DEPARTMENT OF DEVELOPMENT SERVICES – PLANNING DIVISION
REPORT: Special Permit & Site Plan for 1420 Park Street
for consideration September 27, 2022

STAFF REPORT

PROJECT: Craftsman Industrial/Brewery
1420 Park Street
PARCEL ID: 159-403-078
P&Z-COMM-2022-0624

TYPE: Site Plan for Craftsman Industrial per Sec.1.3.3 and a Special Permit for an Outdoor Café associated with a Drinking Place per Sec.3.5.2.D.(1)(c).

Figure 1. Site Plan & Landscaping – Lifecare Design 2022

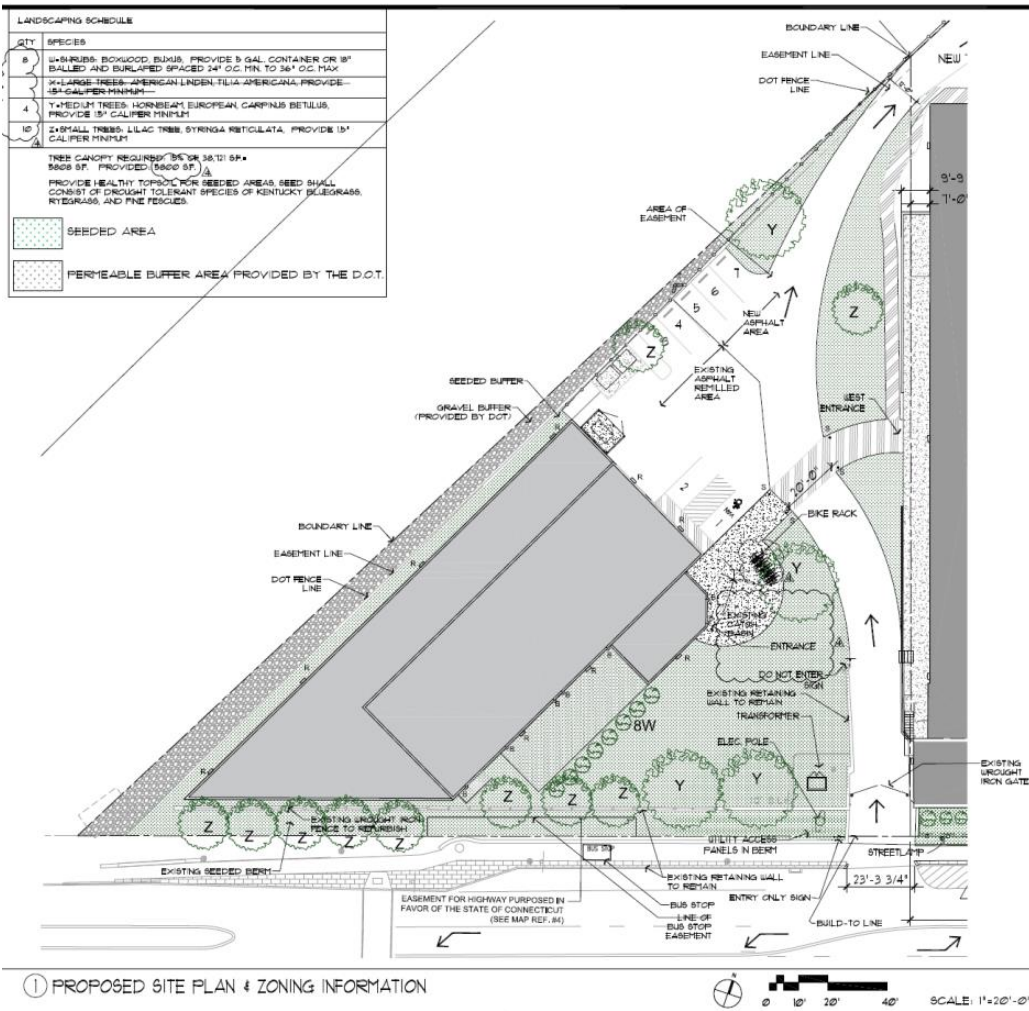
The proposed site plan includes parking lot improvements, landscaping, façade renovations and the integration of the subject property into the internal pedestrian circulation system of the neighboring Parkville Market. These improvements are proposed in conjunction with the establishment of a craftsman industrial use (a brewery) at the subject property. The craftsman industrial use allows for a drinking place and associated retail by right. The proposed floor plan shows a tap room and seating consistent with the request and the floor plan meets the requirements of Section 3.3.7.B for craftsman industrial establishments.

The following analysis is based on the revised plans and narrative received by staff on September 16, 2022. The proposed façade improvements will bring the facades into compliance with the zoning regulations for a Downtown General Building. The landscaping plan was approved by the City Forester and the plans show tree canopy coverage consistent with the Regulations. Staff are generally in support of the proposed site layout with the following exceptions: The proposed pedestrian circulation system (See Figure 6) requires patrons to walk through the neighboring parcel and through the neighboring building in order to access the site. This condition was found to be undesirable by both the City Pedestrian and Bicycle Coordinator and the City Engineer. This condition was found to be unacceptable by the Fire Marshall. The Fire Marshall confirmed that a more direct route to the ROW is required. A more direct route is also desirable considering the pedestrian oriented goals of the Zoning Regulations and the POCD. The applicant has stated this connection is not feasible. However, in a previous iteration of the plan (see Figure 7), the applicant showed a pedestrian entrance via a new stairwell connecting the subject property directly to Park Street. Staff find that a similar pedestrian connection should be constructed in order to comply with the Fire Code and the Zoning Regulations special permit requirement to “Provide pedestrian amenities” per Sec.1.3.4.D(2)(m).

The photometric plan and fixture details provided on sheet SL-1 confirm compliance with the regulations with the exception of several decorative fixtures proposed within the ground floor outdoor café and adjacent to the front entrance. These fixtures are not shielded and have the potential to create glare, however they are notated as relatively low luminance fixtures and the photometric plan confirms that no light pollution will be thrown onto adjacent properties as a result of the fixture type.

1. A direct pedestrian connection that meets the Fire Code for egress shall be provided from the principal entrance of the subject building to Park Street;
2. The applicant shall demonstrate that the proposed work will meet the basic requirements of Sec.6.14 regarding stormwater management.
3. The applicant shall provide an erosion and control plan or confirm exemption from the requirement per Sec.6.16.3.
4. The bike rack shall be of a design consistent with Sec.7.3.3 of the Regulations.

Figure 2. Roof top outdoor café – Lifecare Design 2022

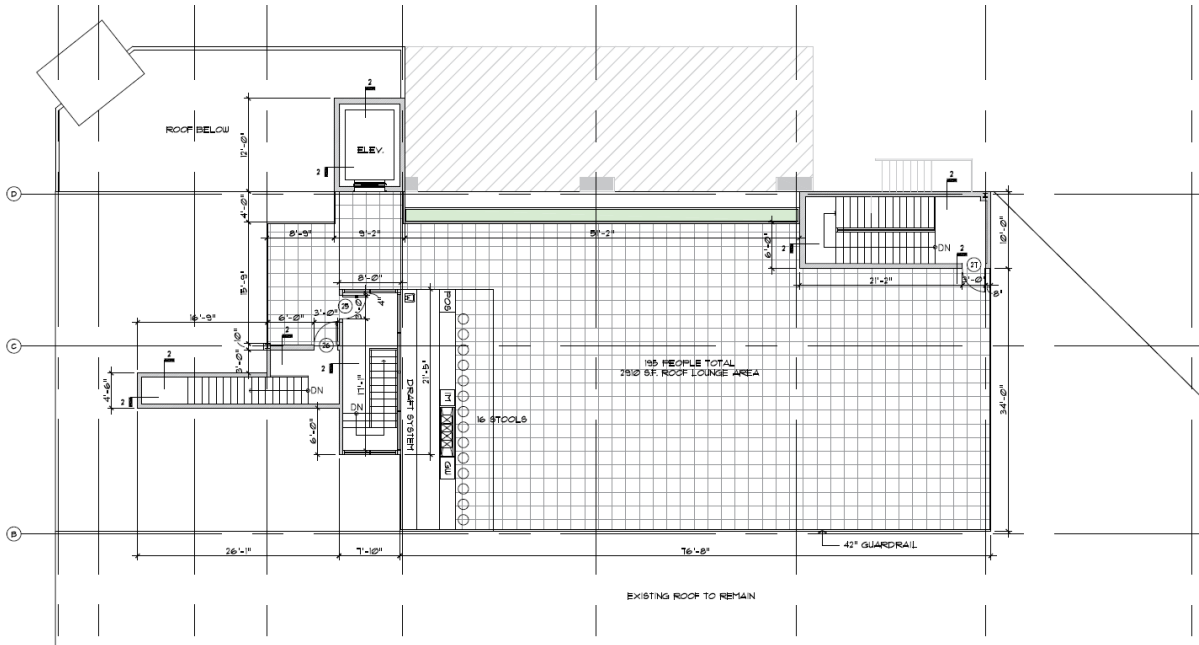
- There are two areas to be used for outdoor cafes at the subject site:
 - One outdoor café area measuring ~20' by 50' is proposed directly adjacent to the main entrance on the east side of the building;
 - The second outdoor café area is a 2,910 sf area on the roof of the building.
- Both proposed outdoor café areas will be enclosed by a 42" guard rail and will not encroach past the building line.

The proposed outdoor café areas meet the general requirements of 3.5.2.D regarding placement and enclosure. Section 3.5.2.D empowers the commission to limit the overall size of the outdoor café, however staff finds no basis for restriction in this case. Both the proposed area at the front of the building and the larger outdoor space on the roof of the building are consistent with the *Play400 – Expand Outdoor Dining* goal of the Plan of Conservation & Development (POCD).

Figure 5. Proposed East Elevation – Lifecare Design 2021

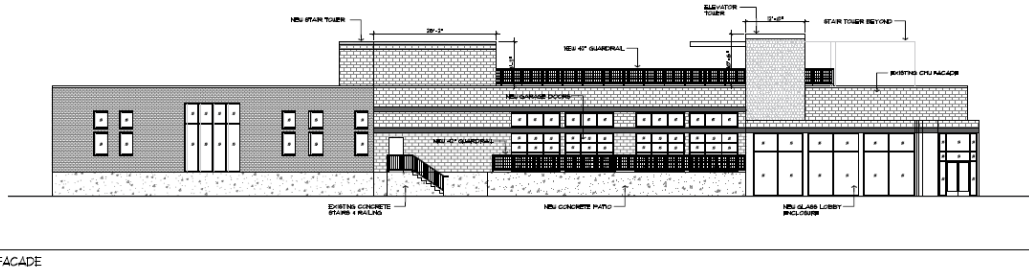
3. I noticed that the proposed elevation drawings do not match what was approved by the historic preservation board 12/15/21 (COMM-2021-0548). **Paige Berschet** will confirm whether this will require additional review by HPC. **The street façade has changed very little from the approved elevation in Dec. 2021. The east elevation has been changed by providing a straight canopy at the terrace, instead of a curvy one.**

Figure 7. Previous iteration of the site plan showing pedestrian connection to Park Street – Lifecare Design submitted to the Planning Division in 2018

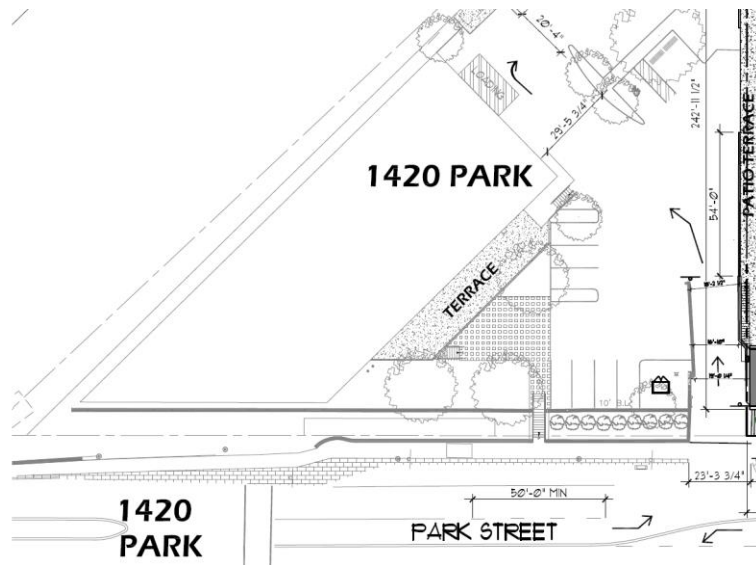
“This site plan proposes to have pedestrian access connect to the site through the interior of the building in the adjacent parcel. The design is inadequate in that the proposed location for pedestrian access fails to provide a direct and readily accessible path for users, which may include transit riders, pedestrians, cyclists, and those with mobility challenges. The path through the interior area may also pose challenges for wayfinding, causing vulnerable users to opt for less safe alternatives such as car-only driveways. Moreover, pedestrian / public access to the site would be dependent upon the hours of operation of a separate building on a separate parcel, which may lead to conflicts or challenges in the future. Notably, the applicant has considered alternate options for pedestrian access in previous iterations of the site plan.”

PROPOSED SITE PLAN, ZONING INFORMATION, SITE DETAILS & SCHEDULE

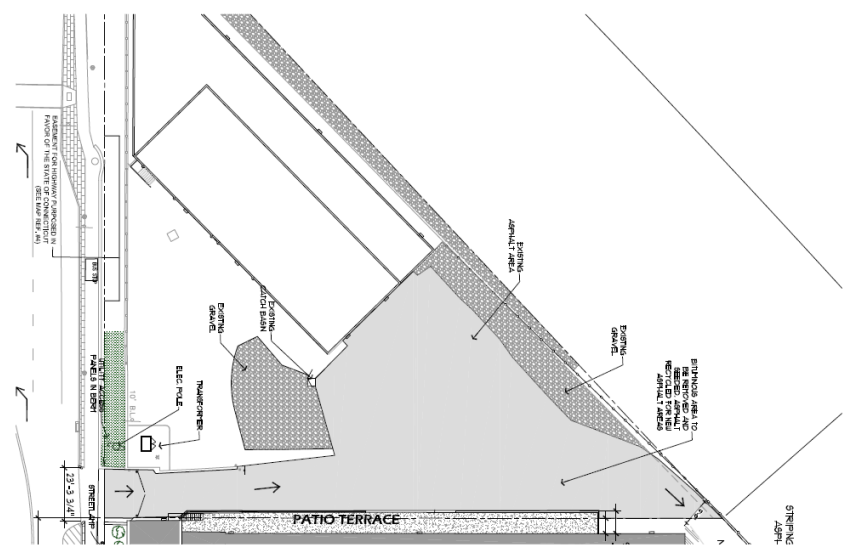
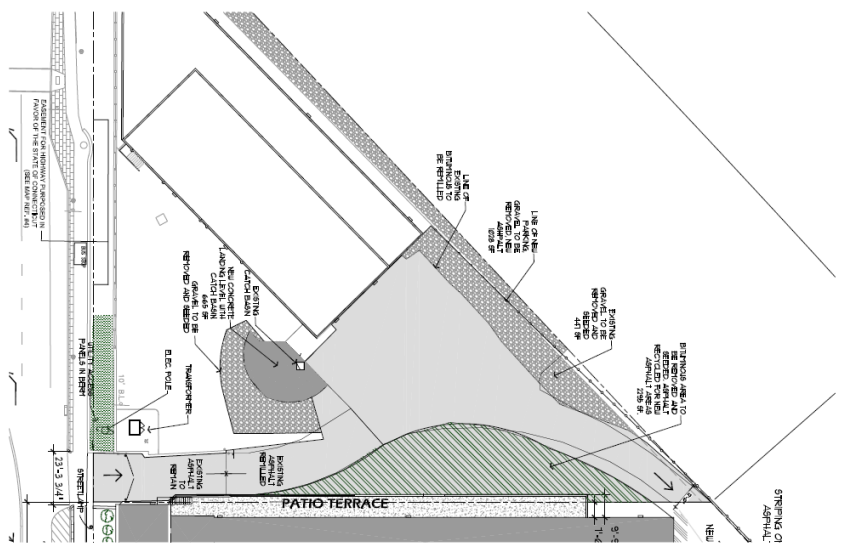
1. Please include a survey in the plan set. **Survey is included.**
2. Landscape plan was delivered to the City Forester’s representative for review. **Lansdaping Distribution has been revised.**
3. In zoning table on sheet SP-1. Multiple items are marked “Variance Accorded”. I don’t see a variance(s) on file. Please provide verification of a variance issued by the Zoning Board of Appeals for these items. Please note items #2 and #16 do not require variances. Item number 24 and 25 should be met. **Variances attached**

4. Section 4 on sheet SP-1 implies there is a minimum number of parking spaces and does not reflect City of Hartford parking requirements. **Maximum** parking for this use is 4 spaces per 1000 sf (see employment uses [i.e.craftsman industrial] in Fig.7.2-A). Revise table to show adherence with Hartford regulations. **Table revised on SP-1.**
5. Bicycle parking cannot be more than 50’ from the entrance to a building and located on the same lot per Sec.7.3.3. Please show bicycle parking on site. **Shown on Sp-1.**
6. The ADA parking is currently shown in what could be the side or front yard. Parking is not permitted in this location. Please remove from the plan. **Parking was removed.** Staff found no record of parking being approved in this location in the past.
